DOCKET
01-AFC-19C

SUBJECT: COSUMNES POWER PLANT (01-AFC-19C):
PROPOSED GATE REORIENTATION RESPONSE LETTER

Subject: Cosumnes Power Plant (01-AFC-19)
Proposed Gate Reorientation

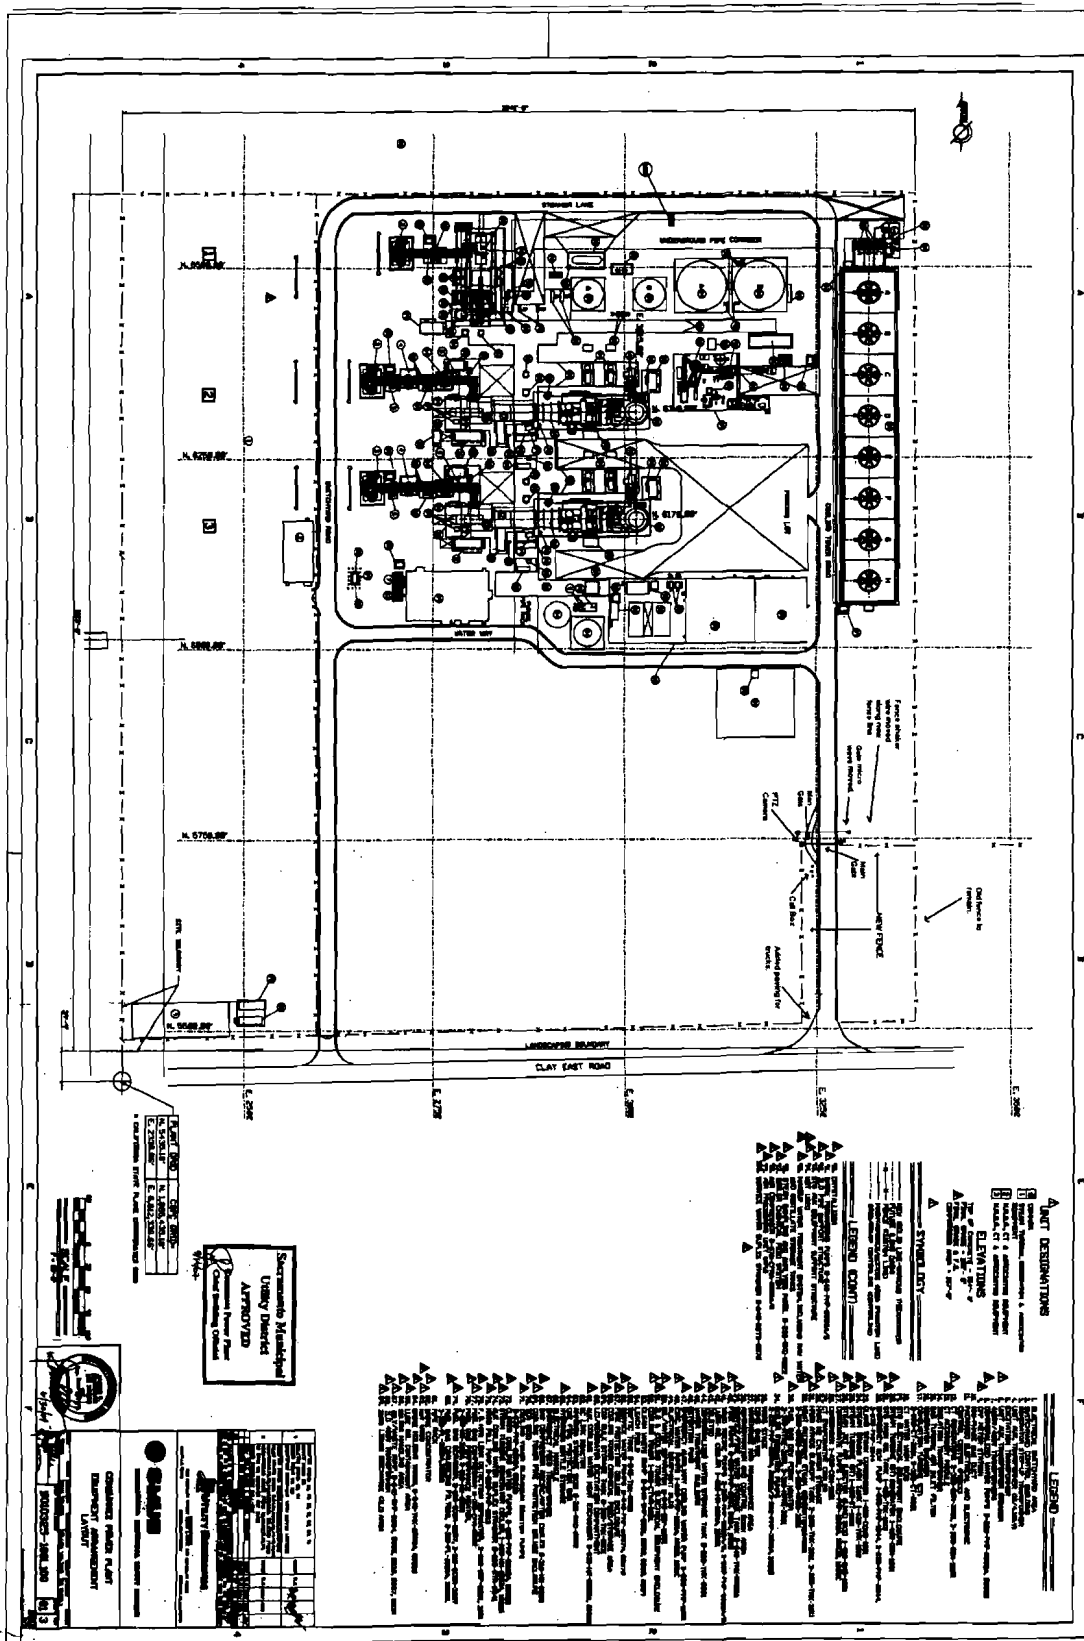
This letter is to inform you of the Cosumnes Power Plant's desire to move the east (main) entry gate approximately 130 feet north of its current location in order to enhance public safety and the safety of visitors waiting permission to enter CPP. The current entry protocol requires all visitors and delivery vehicles (including UPS, FedEx, chemical suppliers, etc.) to communicate via intercom with control room personnel in order to gain entry to CPP after identification is visually verified. In addition, larger delivery vehicles, particularly those conveying materials, products and chemicals must wait for manifest and vehicle inspection prior to escorted entry. This occasionally exposes vehicles to traffic on Clay East Road while awaiting access. Plant personnel suggested the proactive safety measure of simply moving the gate inward along the existing plant entrance road as shown in the attached sketch. A new fence segment would be installed, but the existing fence would also remain in place to define the current plant boundary and maintain security. This enhancement should provide adequate space and maneuverability to prevent visitors and their vehicles from being exposed to cross traffic.

Energy Commission staff has reviewed your enclosed letter dated July 2, 2010 and email dated Monday 12, 2010 requesting to move the east (main) entry gate at the Cosumnes Power Plant (Project) by approximately 130 feet to the north of its current location. As represented in your letter and email, this proposed modification does not change the Project's design, operation or performance requirements; therefore a Petition to Amend is not required.
